Title	LX Torquing Specification
Date	4 th May 2016
Purpose	This bulletin outlines the updated torquing procedure for LX modules
Scope	This bulletin applies to all LX modules.

Figure 1: LX Module Tightening Sequence

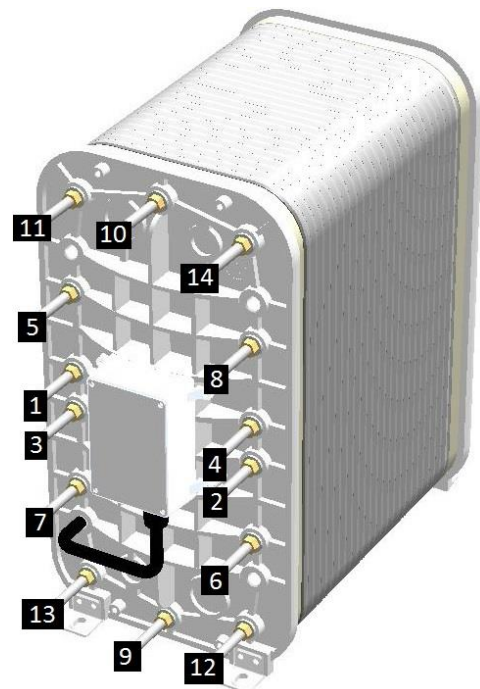
Sequence: Figure 1 shows the sequence in which to re-torque the tie bars. Start the torquing process with # 1, and finish with # 14.

Torque Specification: The finished torque specification for each tie-bar is **25 ft-lbs (34 N-m)**.

1. Using a 19 mm open ended wrench, hold the acorn nuts on the plumbing (cathode) end of the module.
2. Set the torque wrench to **15 ft-lbs (20 N-m)**. Using the 19 mm extra deep socket (IONPURE part number W2T210908) mounted on the torque wrench, turn all 14 tie-bar hex nuts (anode end) to 15 ft-lbs (20 N-m) following the sequence in Figure 1.
3. Re-set the torque wrench to **25 ft-lbs (34 N-m)** and tighten all 14 tie-bar hex nuts (anode end) to 25 ft-lbs (34 N-m) following the sequence in Figure 1.
4. Use caution to avoid over tightening. Do not exceed 25 ft-lbs (34 N-m) of torque.
